NL-09-163

SUBJECT: Relief Request IP3-ISI-RR-04 For Fourth Ten-Year Inservice Inspection Interval
Indian Point Unit Number 3
Docket No. 50-286
License No. DPR-64

RELIEF REQUEST NO: IP3-ISI-RR-04
PROPOSED ALTERNATIVE EXAMINATION AREA

**Relief Request IP3-ISI-RR-04
Proposed Alternative Examination Area
to ASME Code Case N-729-1**

Figure 1

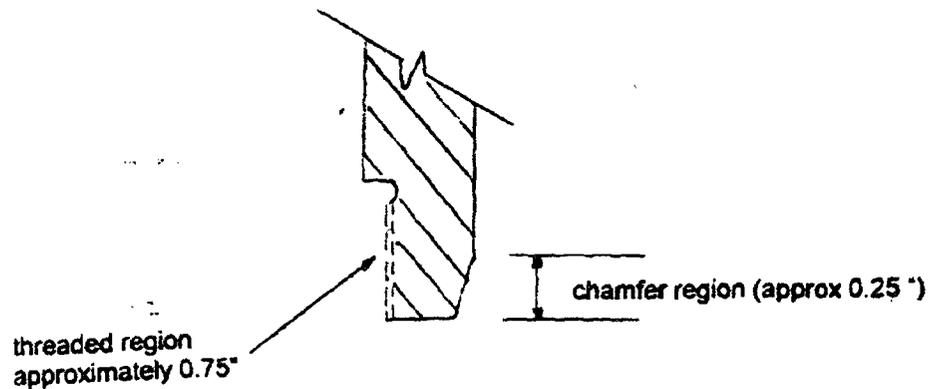
The design of the RPV head penetration nozzles (see Figure 1) includes a threaded section, approximately $\frac{3}{4}$ inches long, at the bottom of the nozzles. The dimensional configuration at some nozzles is such that the inspectable distance from the lowest point of the toe of the J-groove weld to the bottom of the scanned

region is less than the 1-inch and 1 ½ inch lower boundary limit as defined in Figure 2 of Code Case N-729-1.

Use Appendix I of Code Case N-729-1 to define an alternative examination area/volume to that defined in Figure 2 of the Code Case.

Perform UT from the inside surface of each RPV head penetration nozzle from 1-inch and 1 ½ inch above the J-groove weld (i.e., the upper boundary limit defined in Figure 2 of Code Case N-729-1) and extending down the nozzle to at least the top of the

threaded region. Table 1 provides the minimum inspection coverage required to ensure that a postulated axial through-wall flaw in the un-inspected area of the CRDM penetration nozzle will not propagate into the pressure boundary formed by the J-groove weld prior to a subsequent inspection (i.e. 2 Effective Full Power Years, EFPY). The time estimates are more than the time between successive inspections. This exam provides reasonable assurance that structurally significant flaws will not exist at or above the weld root and assure that operation between refueling outages can be accomplished without pressure boundary leakage from the examined nozzles.
